**CHANGE ORDER**

No. 1 (Balancing)

Project Primrose Lift Station and Force Main Upgrades

OWNER's Contract No. S091101

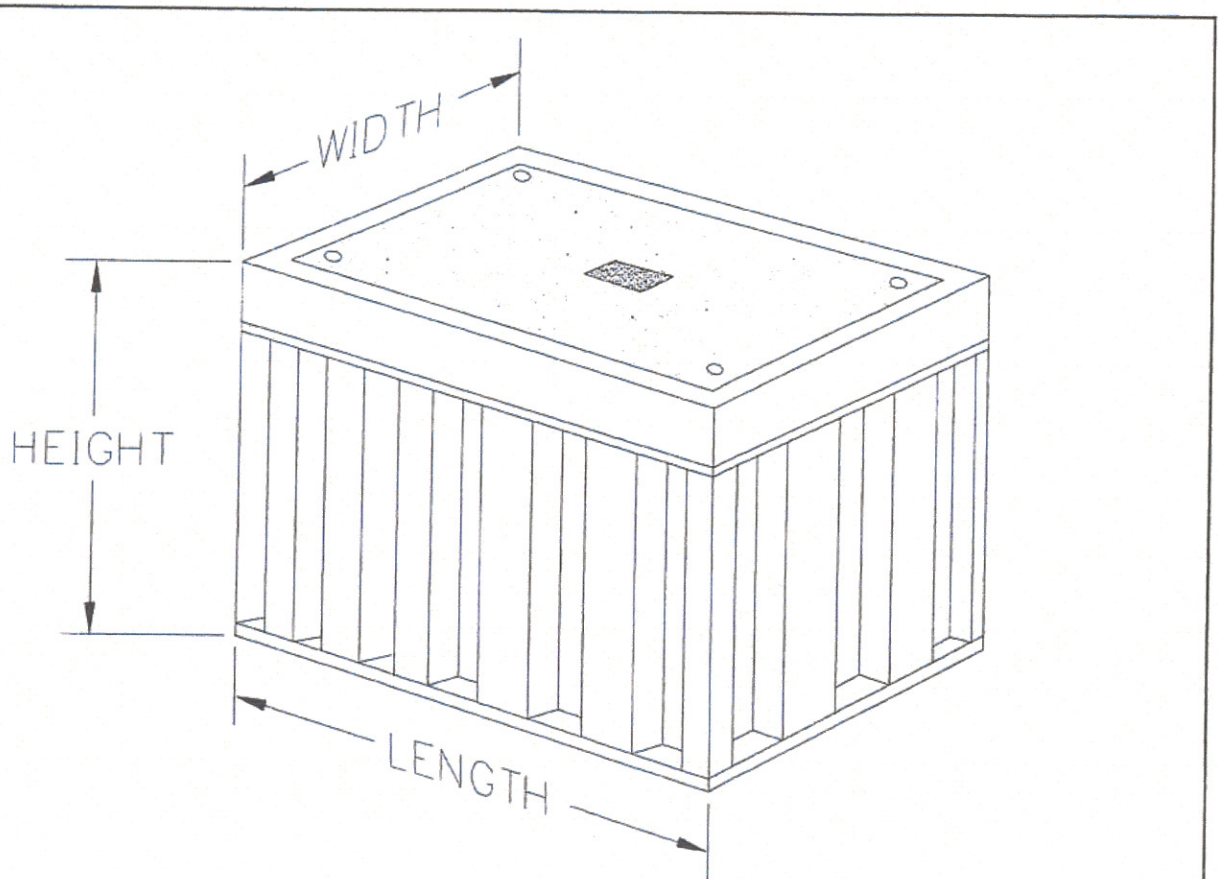
See attached drawings. Please see on page 2 the size of the pull box. Is this the correct size of the pull box?

The pull box specs are in the attached documents. For a three phase primary pull box it will have to be 48" X 96" in size. Any other questions let me know and I will do my best to answer.

That is the correct size pull box. The standard continuous conduit that Entergy installs is SDR 13.5 HDPE.
